TO: Mercedes-Benz and Freightliner Dealer Principals, General Managers, Sales Managers, Service Managers, Parts Managers	FROM: Anthony Washington, Department Manager, Regulations and Certifications
RE: Recall Campaign Notification Model 907 (Sprinter) Model Year 2019 Abutting Wedge	DATE: December 13, 2019

Recall Campaign Bulletin

Campaign No. 2019120002, December 2019

SUBJECT: Model 907 (Sprinter), Model Year 2019 Abutting Wedge

Figure 3: D72.10-A006-11

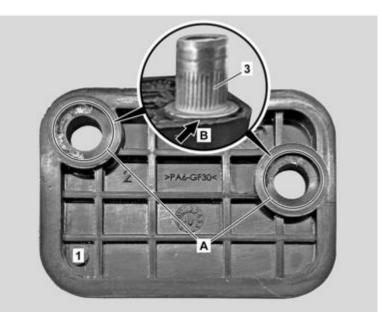
Mercedes-Benz AG ("MBAG"), the manufacturer of both Mercedes-Benz and Freightliner vehicles, has determined that on certain Sprinter VS30 vehicles (platform 907), the wedge-type stop on the B-pillar (abutting wedge) on the driver & front passenger side may not have been installed as intended. The abutting wedge may have been mounted on holes that were drilled too large and/or incorrectly rotated. If a vehicle has an incorrectly installed abutting wedge and is involved in a severe frontal collision, the front doors could compress into the B-pillar. If this were to occur, significantly greater forces may be required to open the doors, which could make it difficult to exit the vehicle or lead to delay in accessing the vehicle from the outside, which could increase the risk of injury to vehicle occupants in the event of a crash. An authorized Mercedes-Benz or Freightliner Sprinter dealer will check the installation of the wedge-type stop and correct if necessary in the affected vehicles.

2 Check torque of screws (2). To do so, tighten screws (2) to specified torque. Nm Bolt, wedge-type stop to B-pillar If the screw (2) or rivet nut (3) turns and the torque is not reached, ↓ replace rivet nuts (3); to do so, continue with operation step 3. If torque is reached, ↓ end the measure.	1	Check installation position of wedge-type stop (1) on left and right B-pillar.	 I Cutout must face toward vehicle interior (see arrow C). If the cutout (see arrow C) of the wedge-type stop (1) does not face toward the vehicle interior, ↓ rotate wedge-type stop (1) through 180 ⋨; to do so, continue with operation step 3. If the cutout (see arrow C) of the wedge-type stop (1) faces toward the vehicle interior, ↓ 	
	2 Remove	-	To do so, tighten screws (2) to specified torque. ^{Nm} Bolt, wedge-type stop to B- pillar If the screw (2) or rivet nut (3) turns and the torque is not reached, ↓ replace rivet nuts (3); to do so, continue with operation step 3. If torque is reached, ↓	BA72.10-N-1011-01TS

3	Remove wedge- type stop (1).	If the installation position of the wedge-type stop (1) is incorrect or the rivet nuts (3) are replaced. i To do this, remove screws (2). Replace screw/bolts (2). If screws (2) can be removed, \downarrow continue with step 11. If screws (2) cannot be unscrewed or if rivet nuts (3) turn, \downarrow continue with operation step 4.	
4	Remove respective seat belt from B-pillar.	If rivet nuts (3) are replaced.	AR91.40-D-1015TS
5	Remove screws (2).	If rivet nuts (3) are replaced.	
6	Remove rivet nuts (3).	If rivet nuts (3) are replaced. ()) Cover up paint surface in working area. This prevents any paint damage. (i) Drill out using a suitable drill bit Ø 8.5 mm.

7	Remove drill chips and residue of rivet nuts (3). Apply zinc dust paint	If rivet nuts (3) are replaced. i The drill chips and residue of rivet nuts (3) can be reached through an opening in respective B-pillar. i Commercially available devices/tools Wet and dry vacuum cleaner If rivet nuts (3) are replaced.	
	around bores.	1K-zinc dust paint	BR00.45-Z-1056-07A
Install			
9	Process wedge-type stop (1).	If rivet nuts (3) were replaced. i The head of the rivet nut (3) must be flush with the outer edge of the wedge-type stop (1) (see arrow B). Process contact surfaces (A) of wedge-type stop (1) using a suitable tool until the wedge- type stop (1) lies flush with the B-pillar.	
10	Install new rivet nuts (3).	If rivet nuts (3) were replaced. i Commercially available devices/tools Rivet nut pliers	
11	Install wedge-type stop (1).	i Cutout must face toward vehicle interior (see arrow C). i To do so, position wedge-type stops (1) on rivet nuts (3), position new screws (2) and tighten. № Bolt, wedge-type stop to B-pillar	BA72.10-N-1011-01TS
